Bulletin No.: 15042

PRODUCT SAFETY RECALL

SUBJECT: HVAC Connector Wire Failure

MODELS: 2006–2010 HUMMER H3

LH drive vehicle shown, RH drive similar.

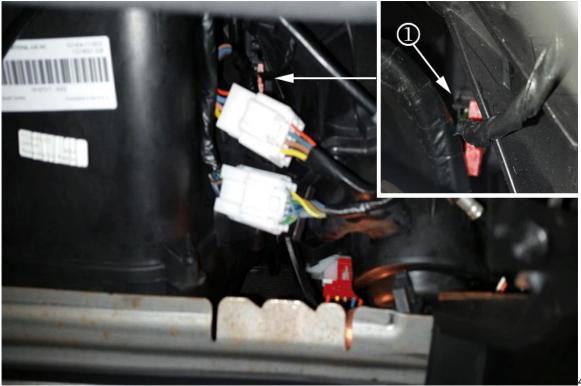
- 1. Move the passenger seat to the rearward position.
- Remove the passenger front side door sill plate. Refer to Front Side Door Sill Trim Plate Replacement in SI.
- 3. Remove the passenger cowl side trim panel. Refer to Cowl Side Trim Panel Replacement in SI.
- 4. Unclip the instrument panel (I/P) courtesy lamp right in the passenger footwell.

- 5. Disconnect the electrical connector from the blower motor resistor assembly (2).
- 6. Remove the blower motor resistor assembly. Refer to *Blower Motor Resistor Assembly Replacement (Left Hand Drive) or Blower Motor Resistor Assembly Replacement (Right Hand Drive)* in SI.
